METROPOLITAN GOVERNMENT OF NASHVILLE AND DAVIDSON COUNTY

STAFF RECOMMENDATION
2014 Cedar Lane
December 16, 2015

Application: Demolition; New construction—Infill and outbuilding; Setback determination
District: Belmont-Hillsboro Neighborhood Conservation Zoning Overlay
Council District: 18
Map and Parcel Number: 11703004200
Applicant: Preston Quirk
Project Lead: Melissa Baldock, melissa.baldock@nashville.gov

Description of Project: Application is to demolish the existing multi-family structure and construct a new multifamily structure with six units and an outbuilding that contains one unit. The outbuilding requires a reduction to the rear setback.

SITE PLAN

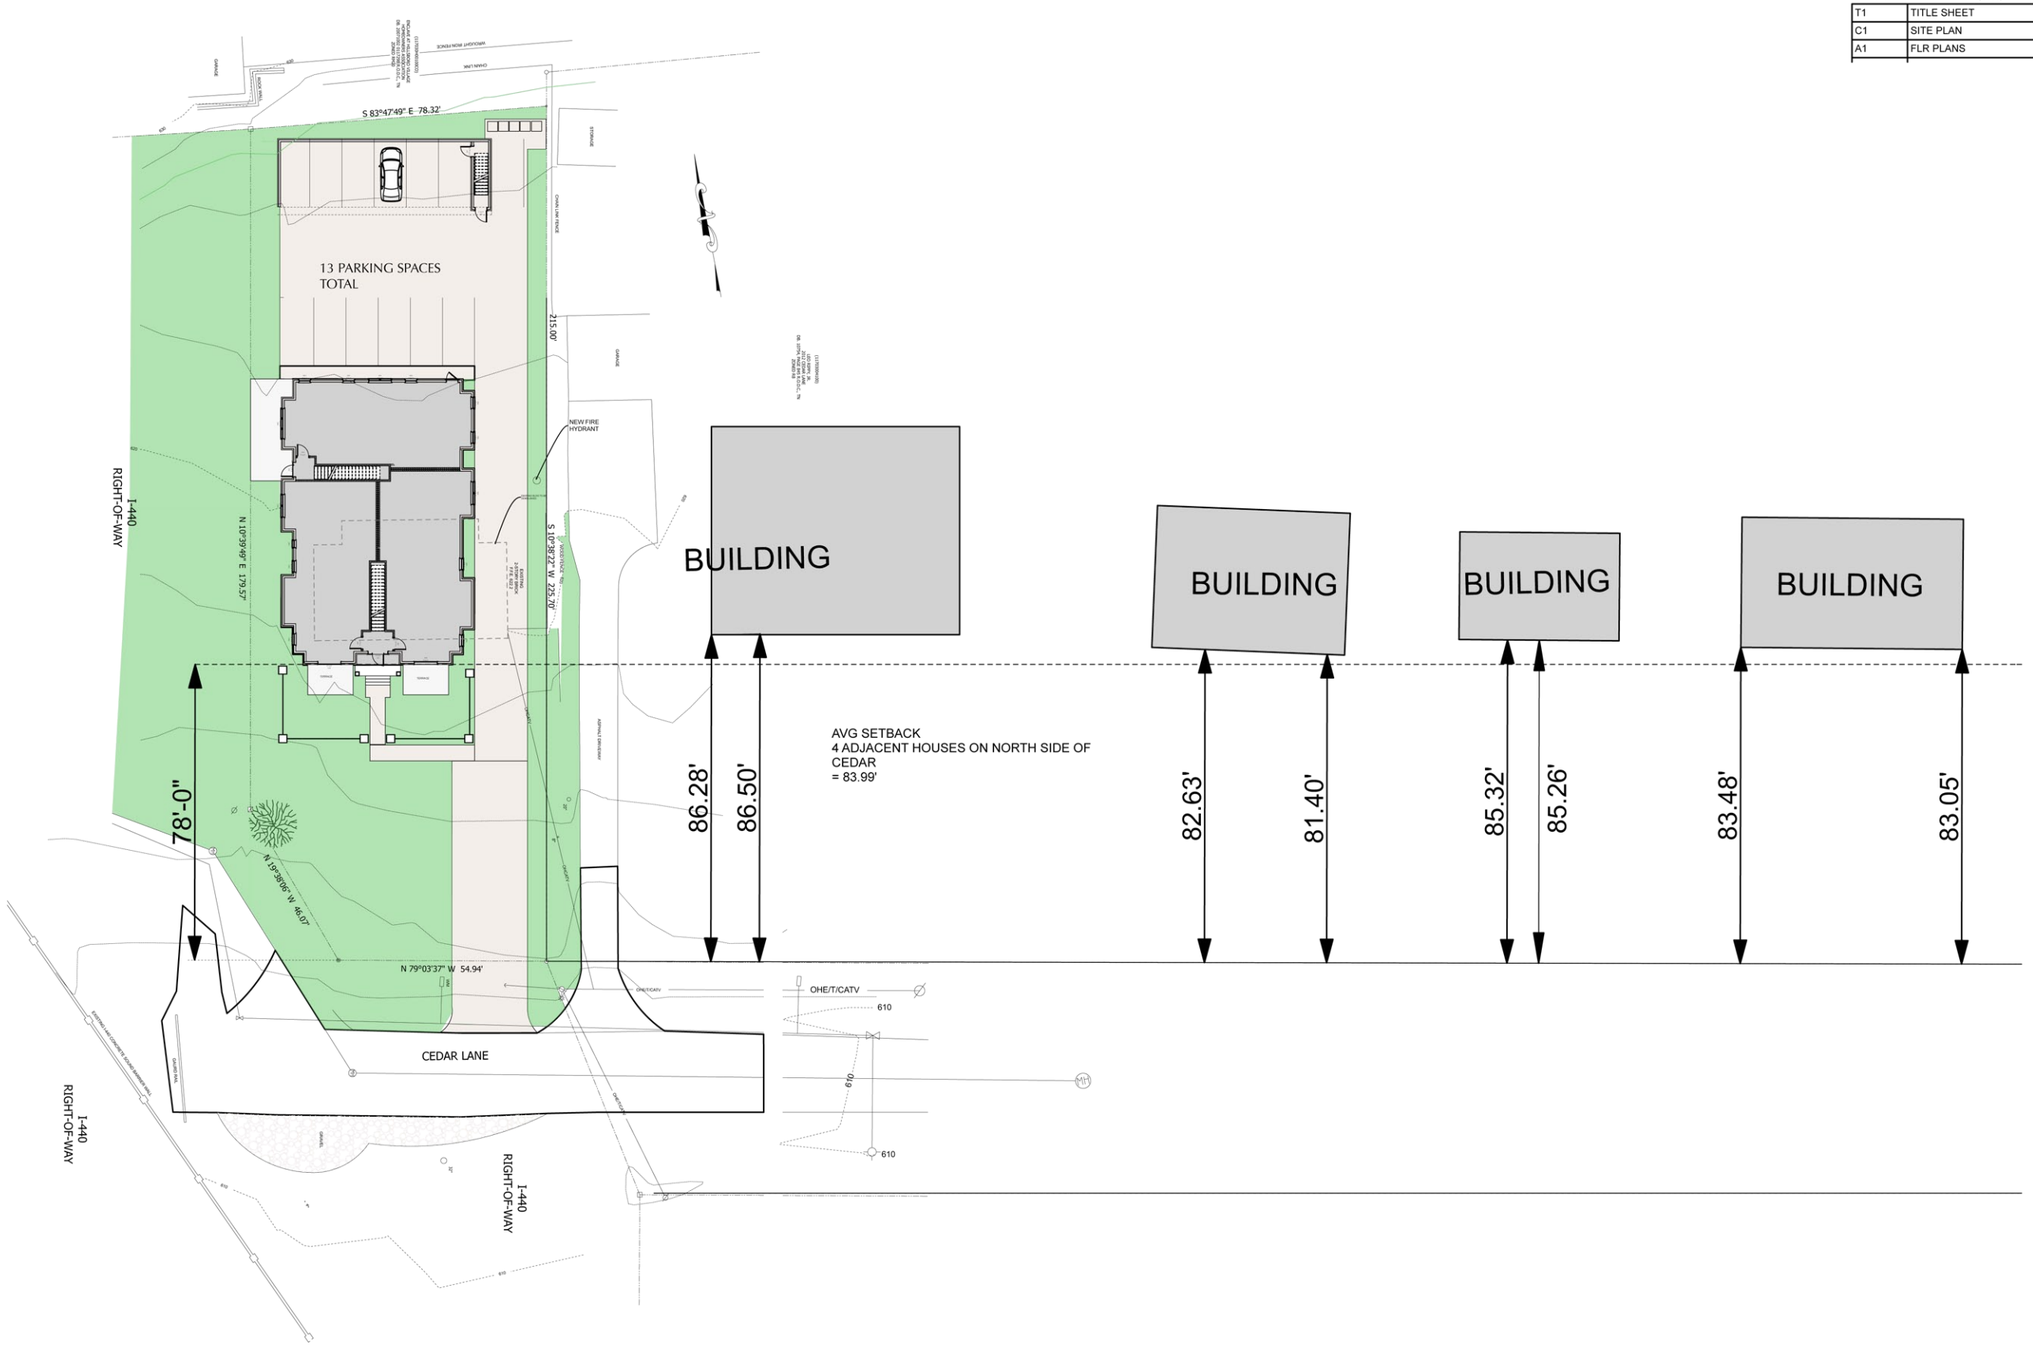
Setback & Rhythm of Spacing: The proposed infill meets all base zoning setbacks. (The outbuilding does not meet the rear setback, and will be discussed under the "Outbuildings" section.) The applicant is proposing to place the structure approximately seventy-eight feet (78') from the front property line. In the previous version of the application, the infill was proposed to be seventy feet (70') from the front property line, so the infill has been pushed back eight feet (8'). The new proposed front setback is still slightly forward of the neighboring historic properties, which are between eighty-three and eighty-six feet (83'-86') from the front property line. The proposed infill will be approximately six feet forward of the average front setback on the north side of the block, which is approximately eighty-four feet (84').

The Commission typically requires that the front setback for infill matches or averages the front setbacks of the adjacent historic houses. However, in this instance, staff finds that the proposed front setback that is forward of the surrounding historic houses is appropriate for several reasons. This site is the last lot before Cedar Lane dead ends into I-440, and as such, there is not a significant rhythm on the street that will be affected. In addition, the proposed front setback allows the owner to realize the seven units the lot is zoned for and to keep all associated parking in the rear yard. Staff finds that the proposed front setback meets Section II.B.1.c. of the design guidelines.

Outbuildings with footprints greater than seven hundred square feet (700 sq. ft.) are required under base zoning to be twenty feet (20') from the rear property line. The applicant is proposing to place the outbuilding just three feet (3') from the rear property line. Staff finds the proposed setback determination to be appropriate because outbuildings historically were located near or on the rear property line. In addition, the three foot (3') setback allows for more space in between the infill and the outbuilding and allows for a larger front setback. Staff also finds the three foot (3') setback to be appropriate because the lot backs up to a larger multi-family development rather than a single-family lot.

FLR PLANS

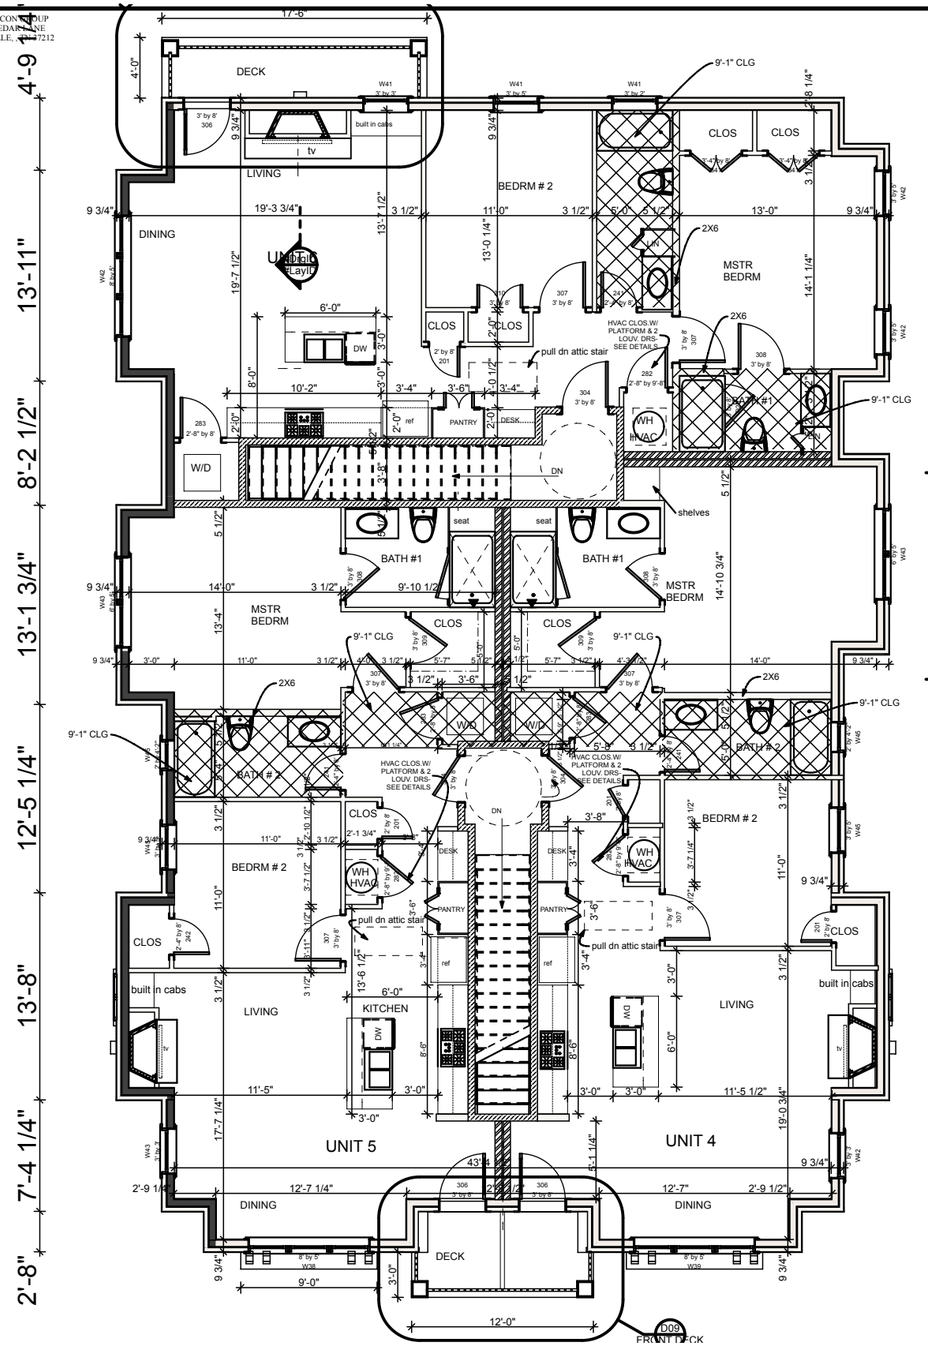
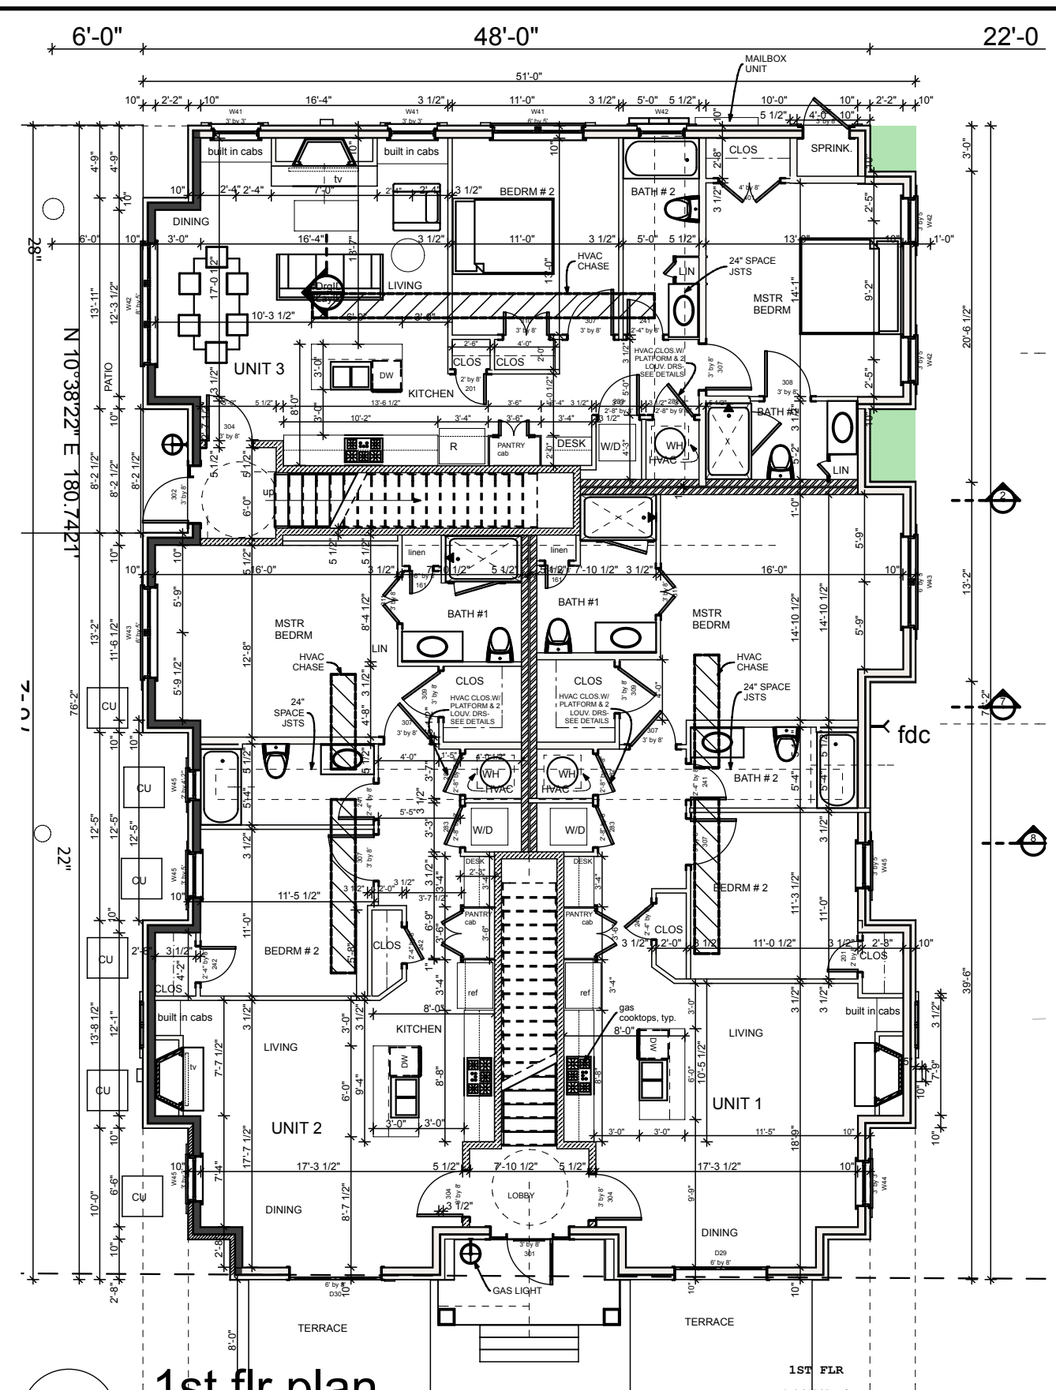
Staff notes that the elevations and floor plans that are part of this application show a depth of seventy-six (76'). Staff recommends that the applicant submit revised elevations and floor plans showing the proposed depth of seventy-five (75') before the permit is issued.

1. The applicant submit revised plans showing the reduction of the primary structure's depth by one foot (1');
2. The finished floor height be consistent with the finished floor heights of the adjacent historic houses, to be verified by MHZC staff in the field;
3. Staff approve the final details, dimensions and materials of windows and doors prior to purchase and installation; and
4. Staff approve the roof color and masonry color, dimensions and texture.

CARRIAGE HOUSE PLANS

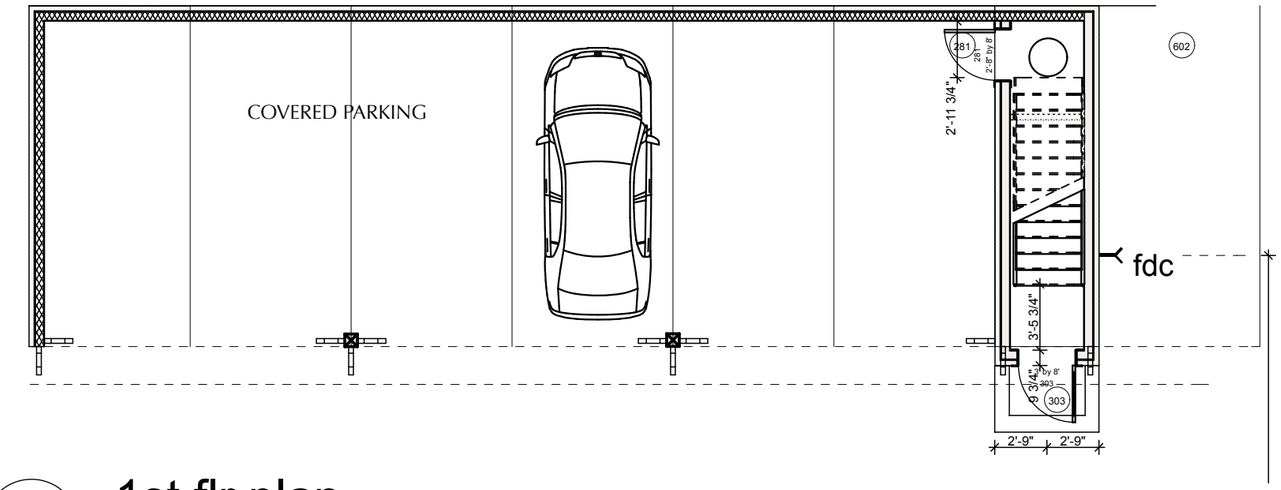
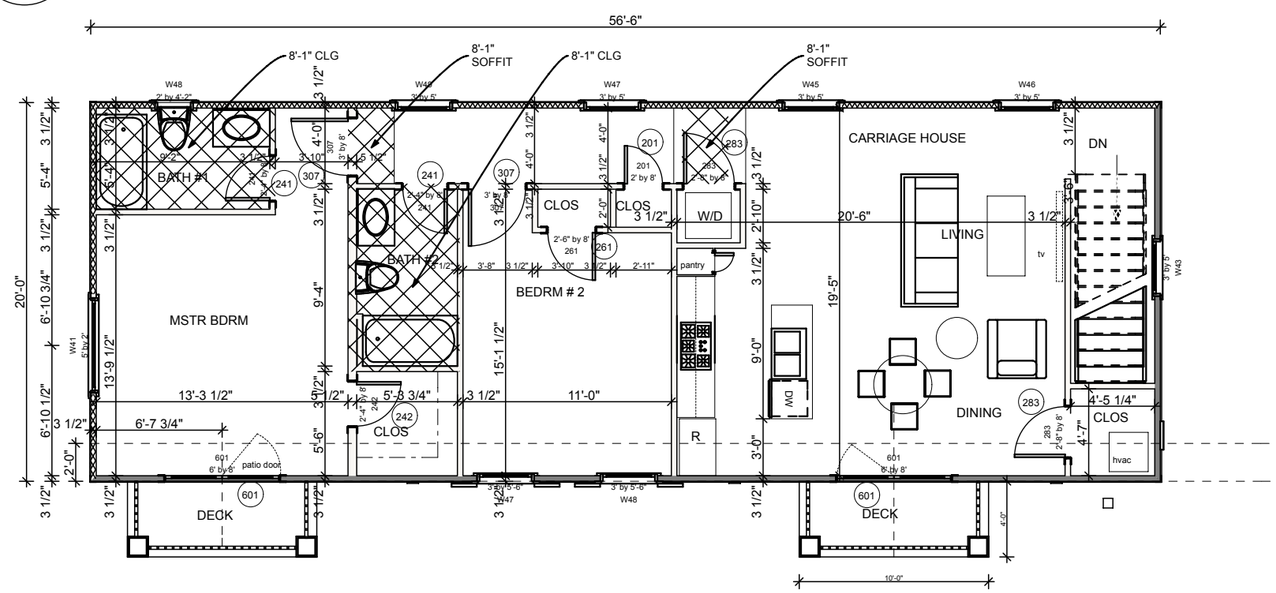
Outbuildings: See attached "Outbuilding Worksheet" for a full analysis of the appropriateness of the proposed outbuilding. The outbuilding will have a footprint of one thousand, one hundred, and thirty square feet (1,130 sq. ft.). This is larger than what is typically approved, but staff finds it to be appropriate for several reasons. The site is unusually large at over sixteen thousand square feet (16,000 sq. ft.) and appears even larger because of the right-of-way to the left. In addition, because the lot is zoned RM20, there are parking and fire requirements that are not typical of the single-family lots in the area.

The outbuilding will be two stories, with an eave height of nineteen feet (19') and a ridge height of twenty-four feet, six inches (24'6"). The second story will contain a dwelling unit. The structure is not being reviewed as a Detached Accessory Dwelling Unit because DADUs are not permitted in the RM20 zone. However, the RM20 zoning allows for seven dwelling units on this lot, and it is appropriate for one of those units to be located in the outbuilding. Allowing for one of the units to be separated helps to decrease the large massing of the principal building.

1 ROOF PLAN MAIN BLDG

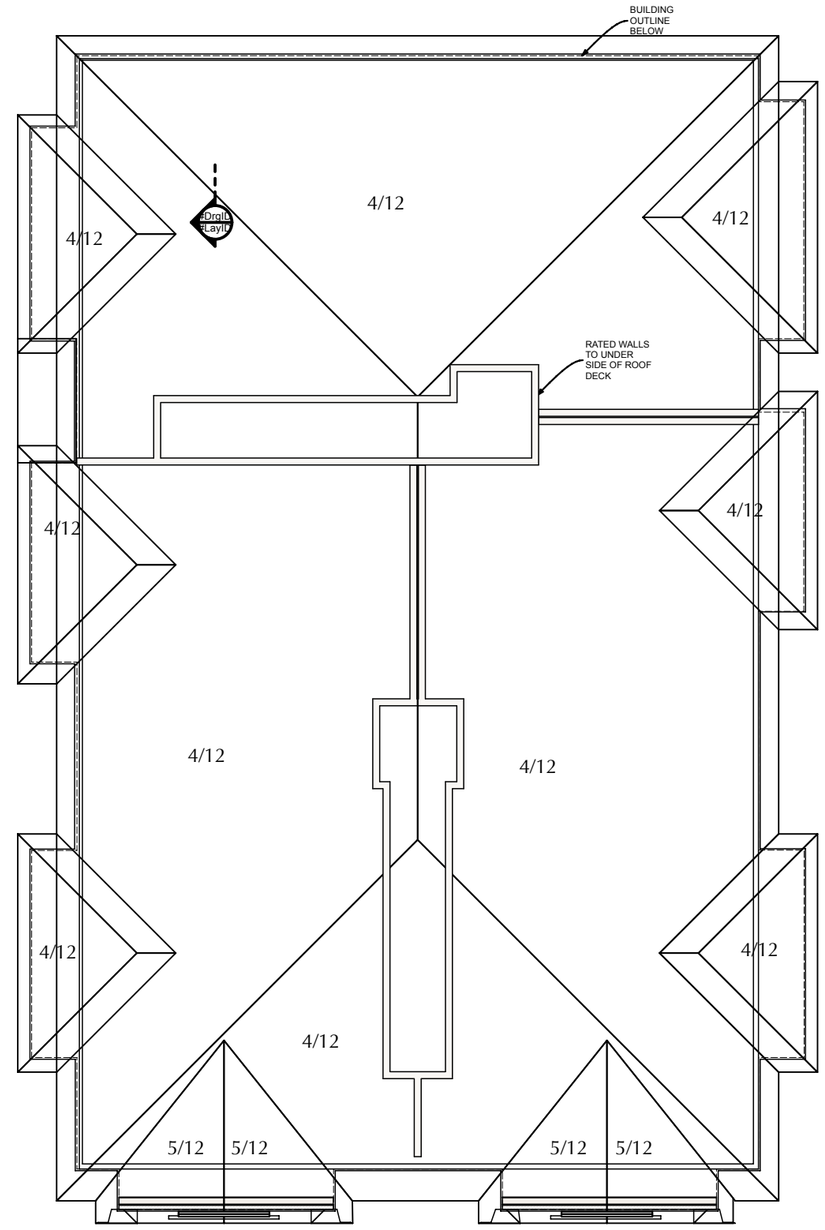
Roof form: The infill's primary roof form will be hipped with a 4/12 pitch. The design incorporates several two-story bays which have hipped roofs that are 4/12 and 5/12. Although the design guidelines state that infill should have primary roof pitches that have a minimum slope of 6/12, staff finds that the lower pitches are acceptable because historic multi-family structures often had lower-sloped, or even flat roofs. Staff finds that the proposed roof form meets Section II.B.1.e. of the design guidelines.
